MEMO

Project name **Station Hill, Reading – Phase 2**
 Project no. **1620004716**
 Client **Lincoln MGT**
 Memo no. **Planning – 001**
 Version **01**
 To **c/o Joel Hallam (Cast) and Don Messenger / Victoria Orbart (DP9)**
 From **Mark Nevill/Matthew Pannett**
 Copy to **Ramboll project team**

This memo provides a response to questions and queries raised on planning conditions 10, 11 and 32 by Reading Borough Council. For ease of reference, the questions and queries (Q) are presented below and Ramboll's answers (A) are in blue text.

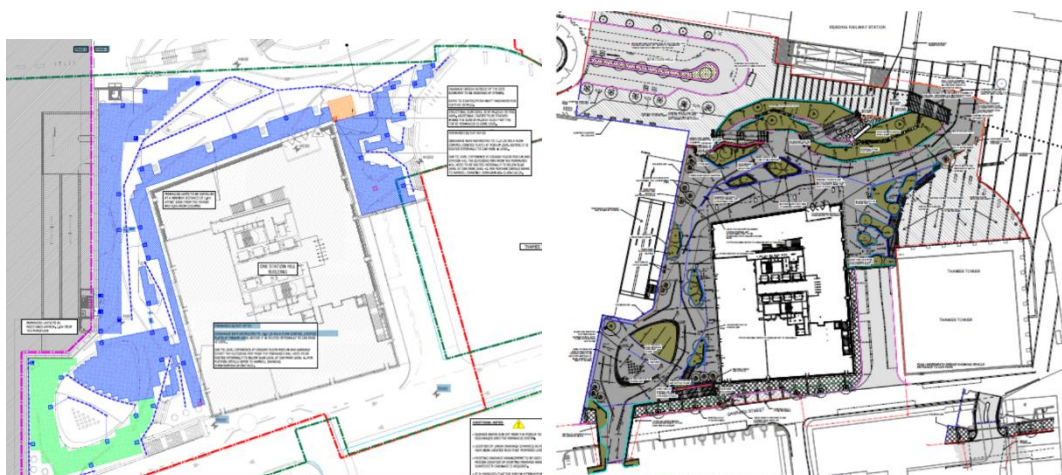
Q. The drainage strategy on this site is complex due to the differing levels and hence extremely difficult to fully appreciate. I will have to assume that the applicant's drainage engineers and landscapers have liaised to ensure that no conflict occurs, i.e. that the proposed drainage strategy will not compromise the landscaping as shown on approved landscaping plans and on detailed landscape plans/details submitted under 211641/APC.

The permavoid crates are proposed in locations of tree planting so it is necessary to seek confirmation of the depth of these under ground (under the ground level at which the trees will be planted where not in raised beds) to ensure that sufficient depth is available for the trees. A comparison the and the approved Landscape GA plan T03 is below to visual the potential issue:

A. The drainage strategy has been developed in collaboration with the landscape Architect and coordinates with the plans / details submitted under 211641/APC; the podium planting and paving levels, including channels and gullies, have been developed to avoid any conflicts. At ground level (effectively Garrard Street) the attenuation tanks are within the footprint of One Station Hill and so do

not create a conflict with any in-ground trees provided as part of the external landscape proposals. Extract from SHRN-RAM-BG-LG-DR-C-0121 below illustrates this relationship with the building and highway:
